**[Docket No. FAA-2000-7958; Notice No. 00-11]**

**Noise Certification Regulations for Helicopters**

**ACTION:** Notice of proposed rulemaking (NPRM).

Figure H1. COMPARISON OF MEASURED AND  
REFERENCE TAKEOFF PROFILES

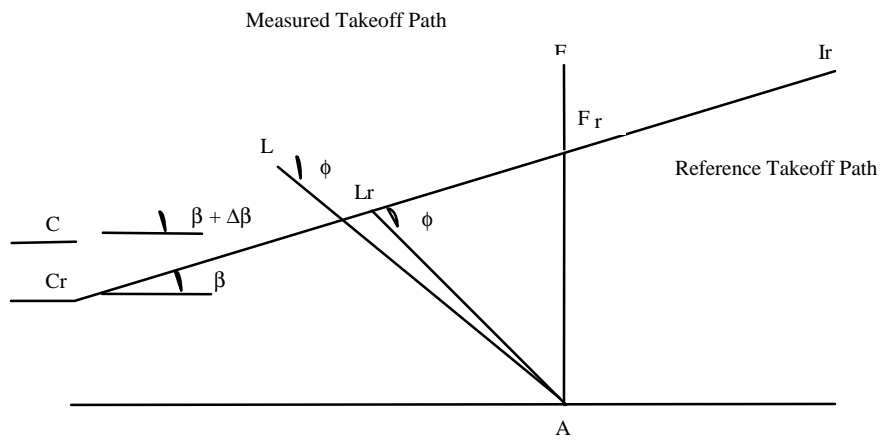
Proposed revision to Figure H1 deletes the designation of Positions Tr since the minimal distance designation is no longer needed and includes the height above measurement point in metric units; see the text of proposed section H36.205(b)(3) regarding the takeoff condition.

In proposed Figures H1, H2, and H3 the titles of the figures are changed to reflect the language of this proposal. The word "reference" would replace the word "corrected" in each title.

Figure H2. COMPARISON OF MEASURED AND  
REFERENCE FLYOVER PROFILES

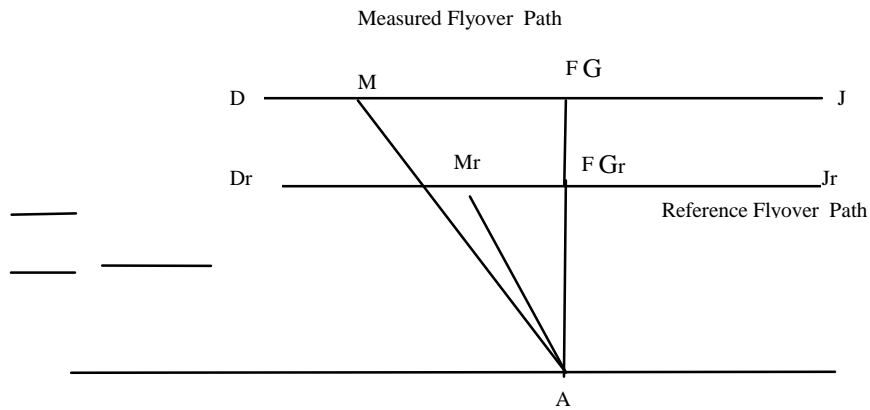
Proposed revision to Figure H2 repositions the bullet-marker that's incorrectly positioned near label G due to a typographical error. The marker is repositioned in the proposed revised graphic image at the intersection of line Dr-Jr and line A-G.

FIGURE H3. COMPARISON OF MEASURED AND  
REFERENCE APPROACH PROFILES

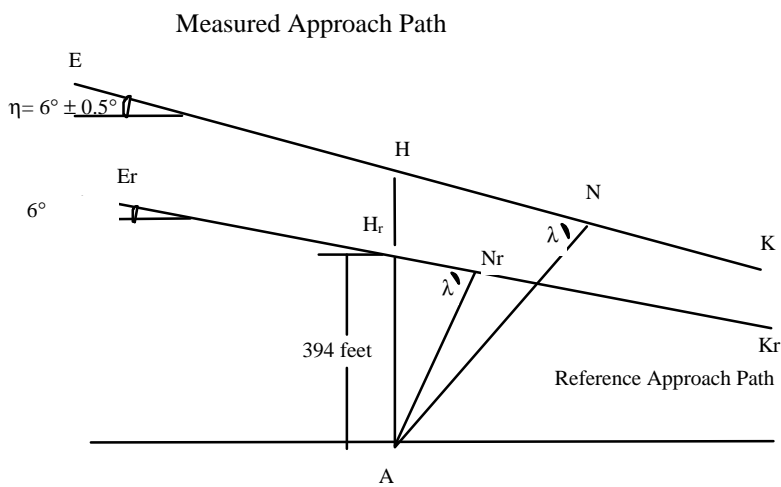
Proposed revision to Figure H3 deletes the designations of Positions S and Sr since the minimal distance designation is no longer needed and includes the height above measurement point in metric units; see the text of section H36.205(d)(3) regarding the approach condition.
